Date of Issuance: 10/30/2020	Effective Date: 10/30/2020
Owner: Douglas County	Owner's Contract No.: 15501
Contractor: Resource Development Company	Contractor's Project No.: 18017
Engineer: Keller Associates	Engineer's Project No.: 216030
Project: NVWWTP Improvements	Contract Name: NVWWTP Improvements

Change Order Descriptions

NORTH VALLEY WASTEWATER TREATMENT PLANT IMPROVEMENTS

INFLUENT STRUCTURE EXISTING 12" SI PIPE PENETRATION

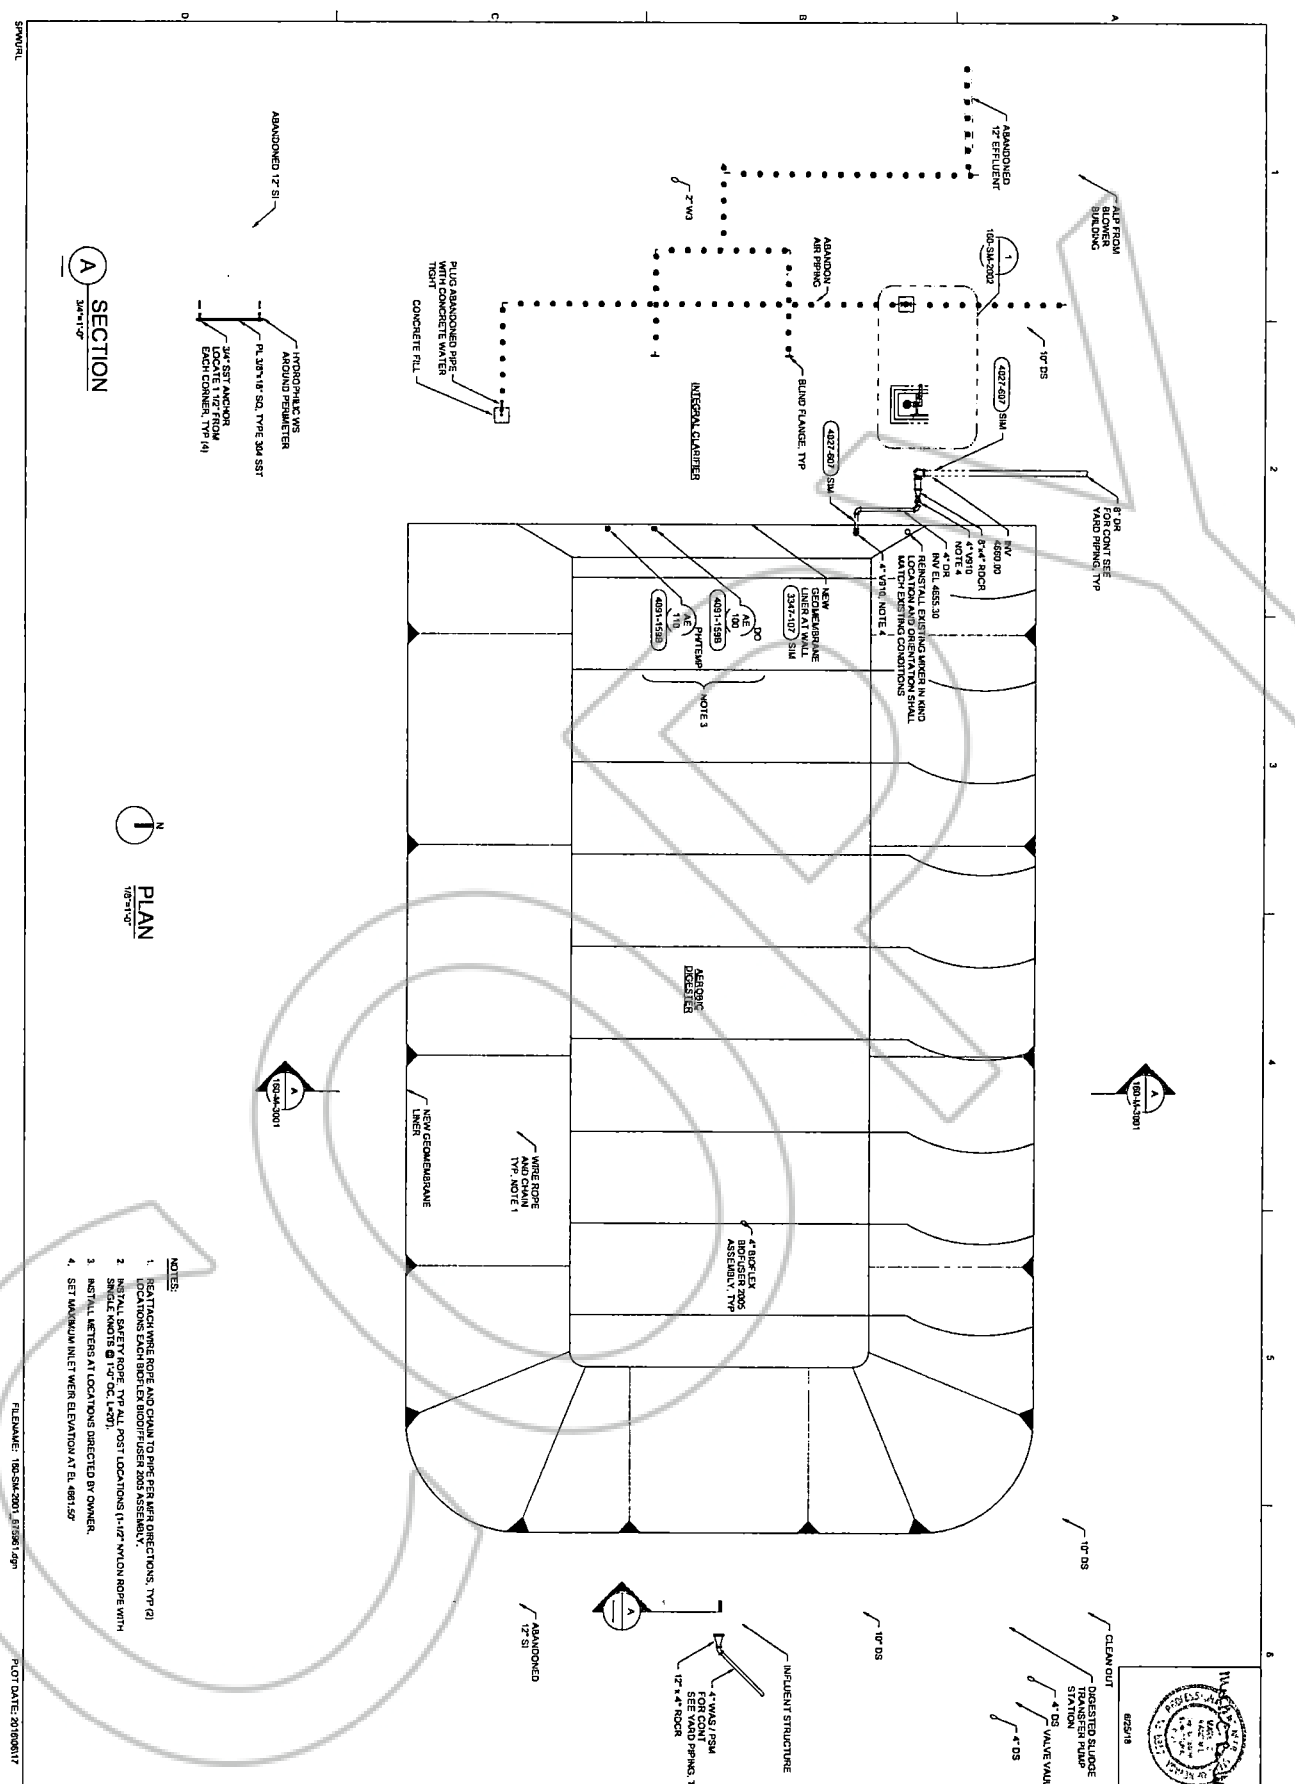
On Sheet 160-SM-2001 Section A we are required to anchor bolt a plate to the vault wall to Abandoned the 12" SI pipe.

The issue is the existing pipe is not flush with the vault wall as indicated on the plans will require RDC to flush cut the pipe and grind the grout flush with the wall in order for the abandonment detail to work.

RDC views the removal of the pipe and grout as as extra work, and will provide PCO pricing once this RFI is responded to.

Proposed approach is acceptable.

DIGESTED SLUDGE HEAT TRACE POWER CONDUIT ROUTING CONCEPT

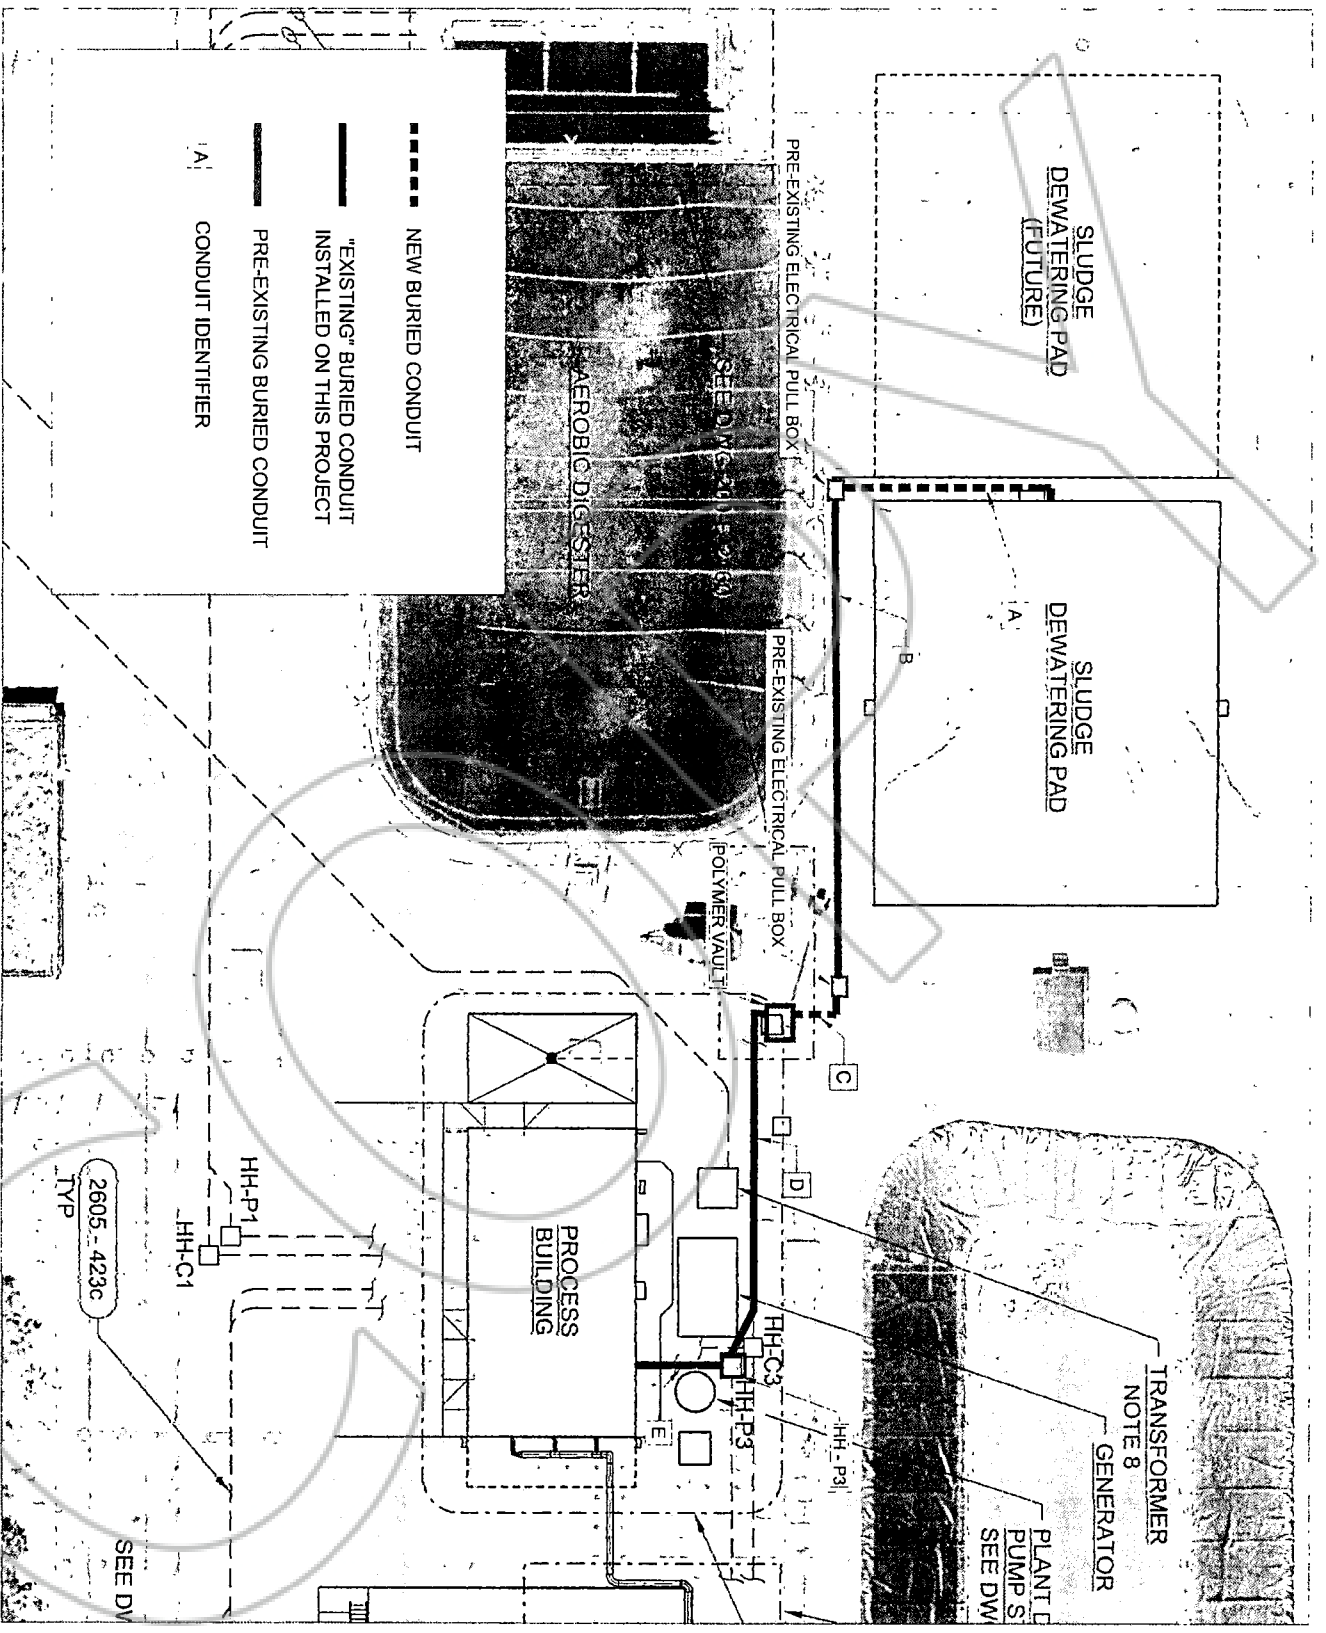
Resource Development Company (RDC) offers the following change proposal for heat trace and insulation extra work in response to RFI #92, RFI #92-2 and RFI #92-3. Scope of work includes: PCO coordination, heat trace circuit layout, remove and replace/upsized transformer feeding panel BCP-151, install additional required circuits (breakers, conduit & conductors), potholing, excavation, backfill, finish grade & type II surfacing, heat trace controller and complete heater set at sludge dewatering pad, testing, start-up and as-builts.

**INFLUENT PUMP STATION
HEAT TRACE LAYOUT
SCHEMATIC**

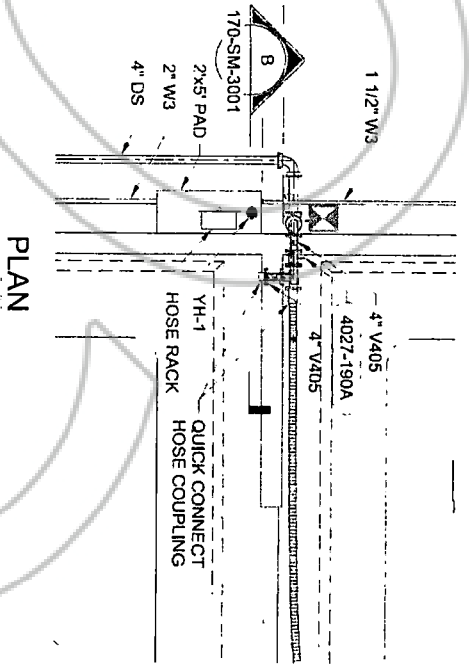
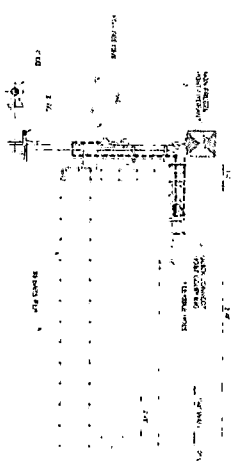
Per the approved design, provisions for heat trace only includes two (2) non-GFCI 120V 300W (VA) circuits from Panel BCP-151 (circuits 11 & 15 on plan sheet 200-E-6001). Heat trace load requirements (see attached) are substantially higher than provisioned on the contract drawings, and may overload the panel(s), as designed. Please provide panel designation (added or upsize panel if needed), breaker configuration, and circuit numbers to accommodate the actual heat trace circuit loads. Note that one additional circuit was added at the SBR to distribute heater loading, now four (4) circuits are required at the SBR, as opposed to three (3) circuits indicated in the original RFI #92.

Provide heat trace circuits from panel BCP-151. Change breakers to those as proposed. See attached recommendation for layout. Lighted end seal terminations are not required but may be an owner preference. Contractor confirm with owner if these are desired for exposed piping. Overall heat trace design appears to be adequate. Contractor confirm spiral method of tracing is being used on larger pipe per spec. Contractor confirm small pipe (1/2" PVC drain pipe) will only have one strip of heat trace. These added loads will require transformer up sizing for BCP-150. Please provide and install the following:

Utility Water Pumps

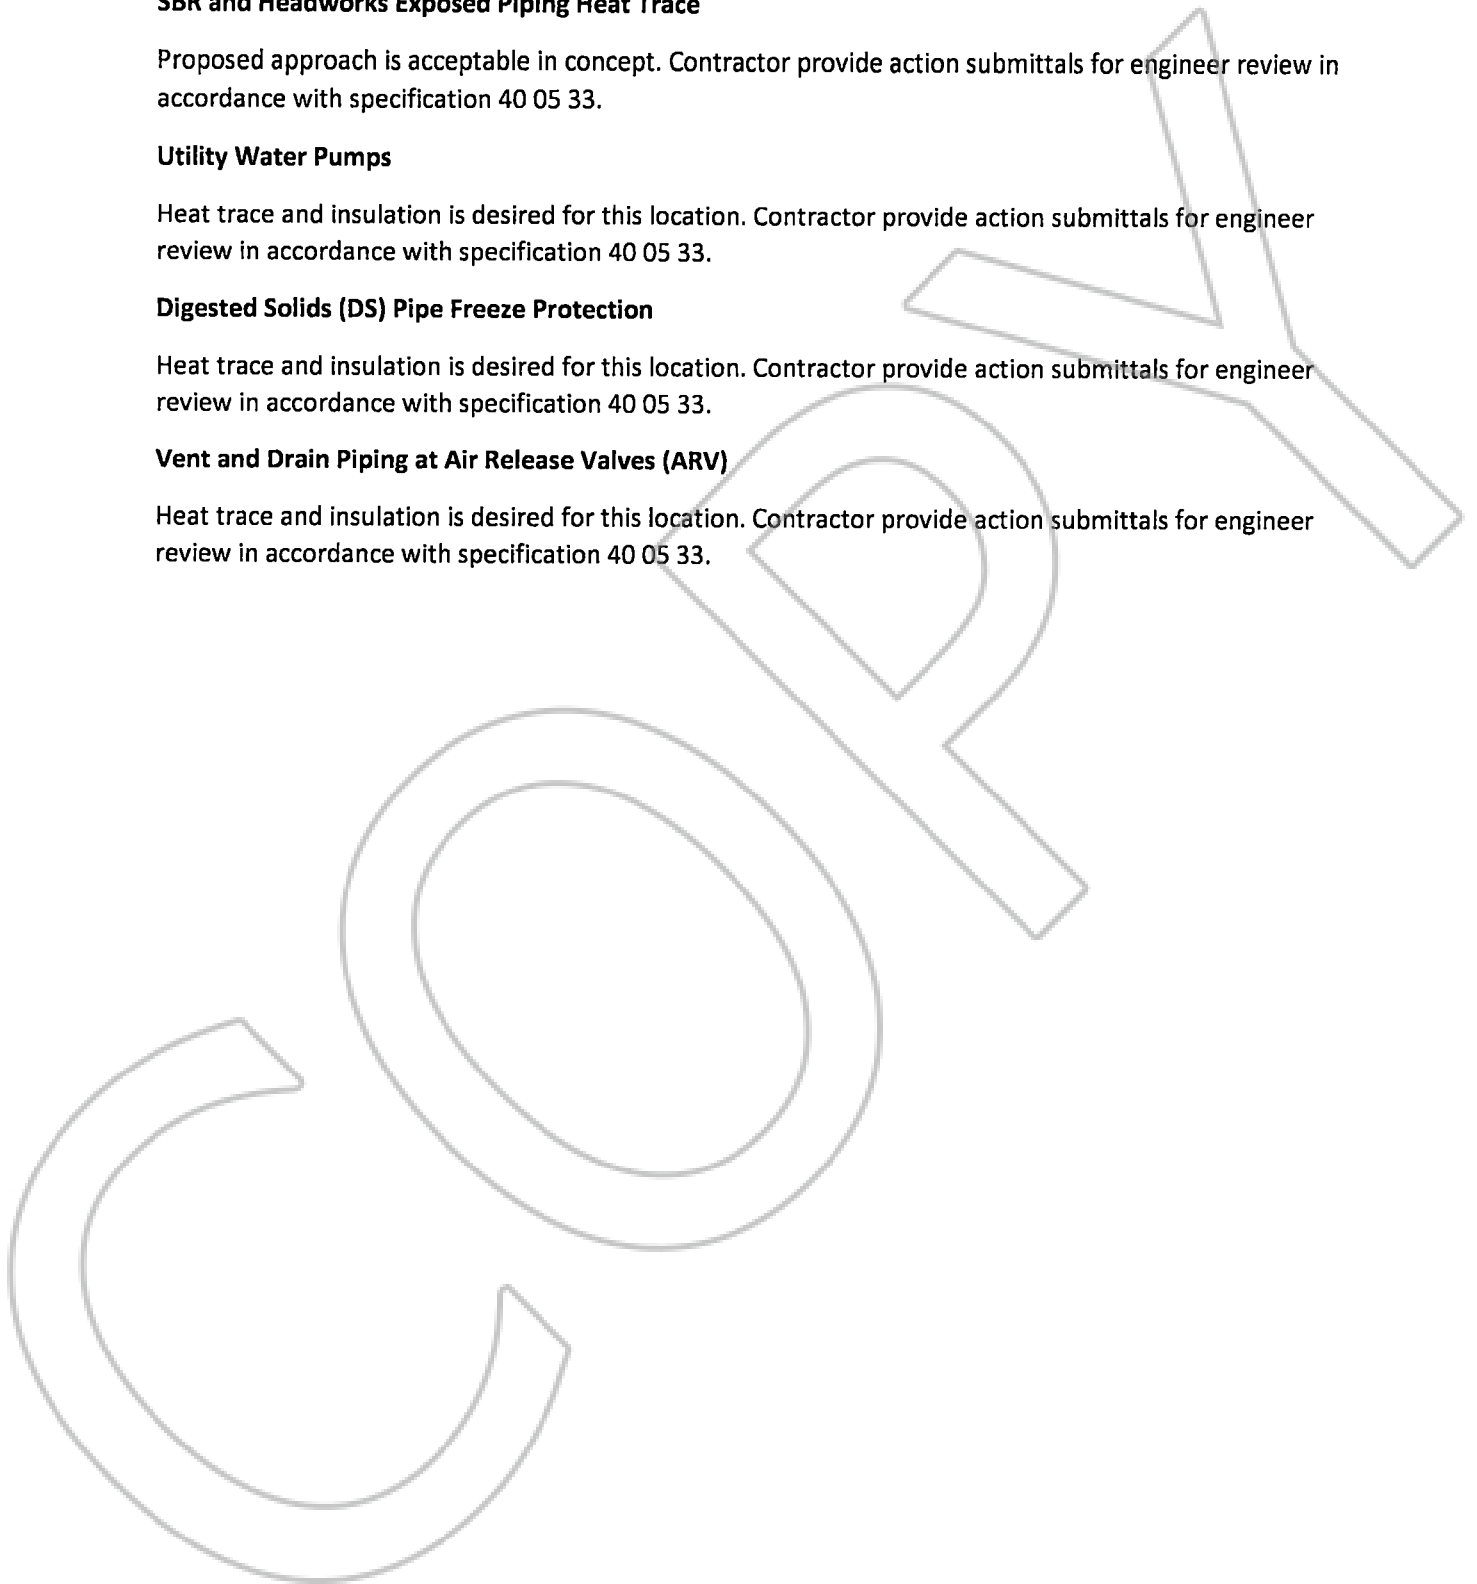
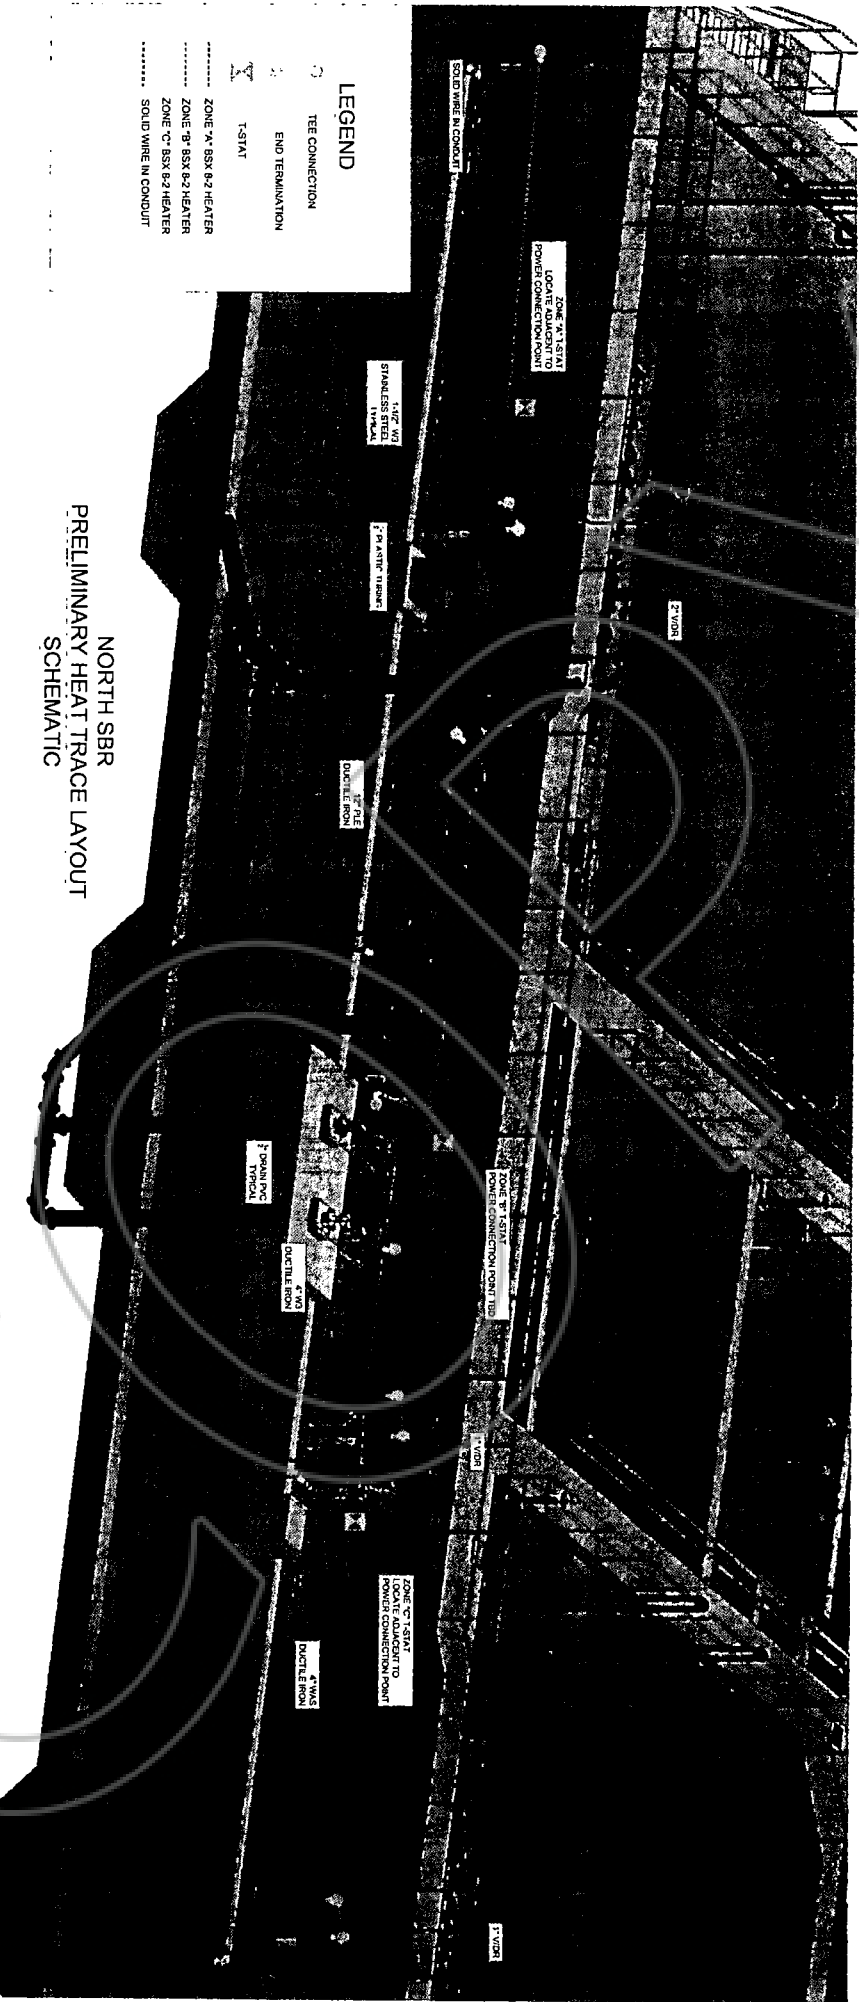
Heat trace circuits included on the plans (two (2) 120V 20A circuits) are insufficient based on initial load calculations provided by the heat trace designer. The designer recommends utilizing 208V heat trace circuits, in lieu of 120V circuits, in order to minimize the total number of circuits required from approximately nine (9+/-) 120V circuits to four (4) 208V. The most cost-effective solution would utilize existing conduits (if possible) routed to existing heat tape connection points identified on the plans. Action submittals will be prepared and submitted following resolution of this RFI.

RDC views the electrical portion of the revisions from the panel board to the power connection points shown on the plans, as extra work (i.e. revised/additional circuit breakers, additional conductors and additional conduits (if any)). Field wiring, components and surface mount conduit required for the installation is RDC's responsibility and not considered extra work.

No freeze protection (insulation or heat trace) is provided for in the plans and specifications for the utility water pumps. Please advise if heat trace and/or insulation is desired for the utility water pumps 130-PMP-110 & 130-PMP-120.

RDC views any insulation and heat trace for the utility water pumps as extra work.

No heat trace circuits are included for the digested solids discharge piping at the sludge dewatering pad. Please advise if heat trace and/or insulation is desired at this location.

Proposed approach is acceptable in concept. Contractor provide action submittals for engineer review in accordance with specification 40 05 33.

Heat trace and insulation is desired for this location. Contractor provide action submittals for engineer review in accordance with specification 40 05 33.

Heat trace and insulation is desired for this location. Contractor provide action submittals for engineer review in accordance with specification 40 05 33.
